**INSPECTION – ENGINE MOUNT CHAFING**

**FIGURE 1 VIEW ON R.H.S OF ENGINE SHOWING REMOVAL OF CLAMPS (IF APPLICABLE)**

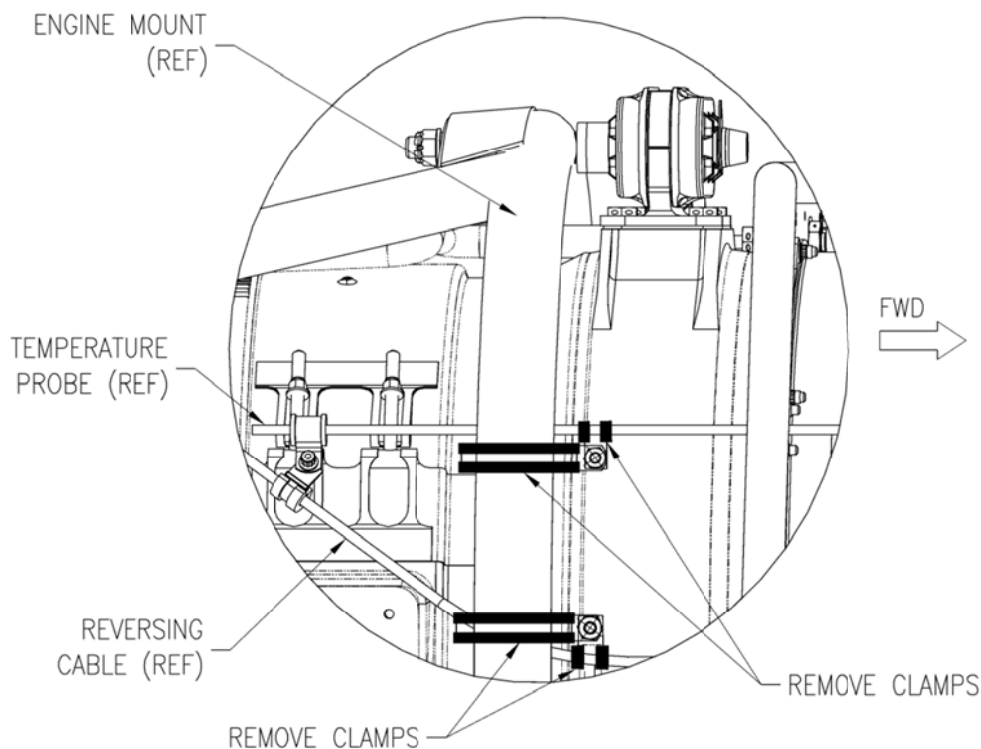
- 1) Remove the Upper Engine Cowl to get access to the Engine Mount inspection area (refer to 750XL Maintenance Manual, Chapter 71).
- 2) If Issue 1 of this Service Bulletin has already been carried out, or if Support Clamps have been fitted at the time of manufacture, proceed as follows:
  - a) **REMOVE** the Support Clamps attaching the Temperature Probe and Reversing Cable to the Engine Mount Tube (refer to Figure 1 below).
  - b) Inspect the Temperature Probe and Reversing Cable for cracking, with particular attention to the attachment of the Temperature Probe to the Fireseal Flange.
  - c) If the Temperature Probe or Reversing Cable Tube is cracked or broken, contact PAL for further information.
  - d) Install anti-chaffing Blade Tape on the Engine Mount Frame (go to Step 4).

- 3) If Issue 1 of this Service Bulletin has not been carried out, inspect the Engine Mount on R.H.S. (See Figure 1).
  - a) If chafing or any damage is present on Engine Mount, Temperature Probe or Reversing Cable, contact PAL for further information.
  - b) If no chafing / damage is present, continue on Step 4).
- 4) Remove the P clip attaching the Temperature Probe to the Reversing cable (See Figure 2).
- 5) Route the Temperature Probe and Reversing Cable to achieve a nominal clearance of at least 1/8" with the Engine Mount Tube with no load applied to the Temperature Probe.
- 6) Reinstall the P clip ensuring that there is no bending pressure applied to the Temperature Probe. The spacer may be relocated or the P clip reversed to suit the no-load Temperature Probe location.

**FIGURE 2 VIEW ON R.H.S OF ENGINE SHOWING INSTALLATION OF BLADE TAPE**

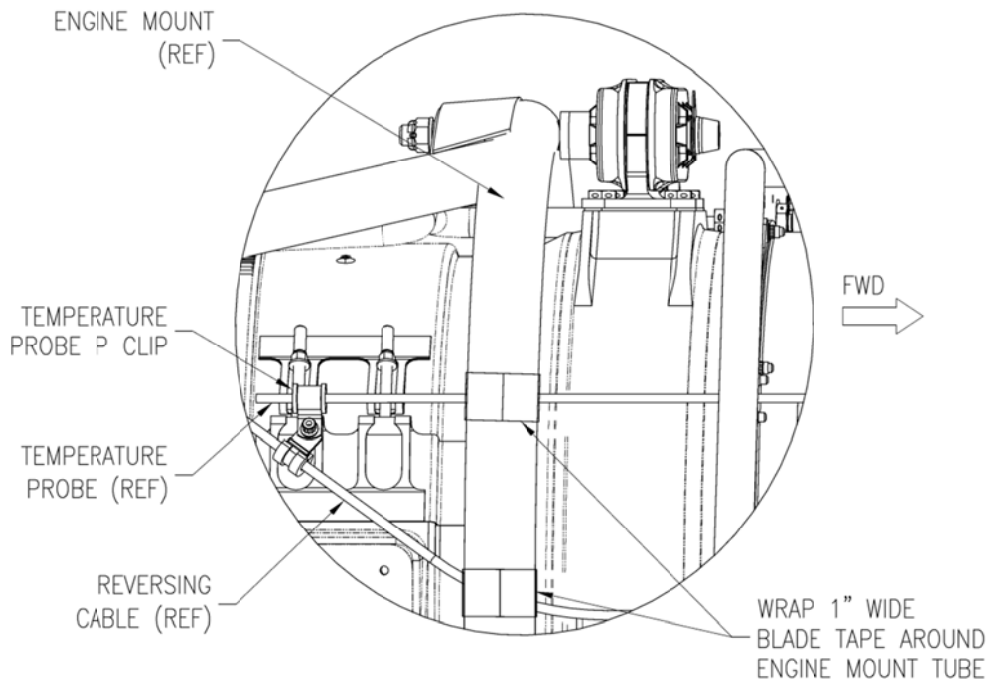
- 7) Ensuring the surface is clean, install 1" wide (min) Blade Tape around the Engine Mount Tube adjacent to the Temperature Probe and Reversing Cable (See Figure 2).
- 8) Reinstall the Upper Engine Cowl (Refer to 750XL Maintenance Manual, Chapter 71).
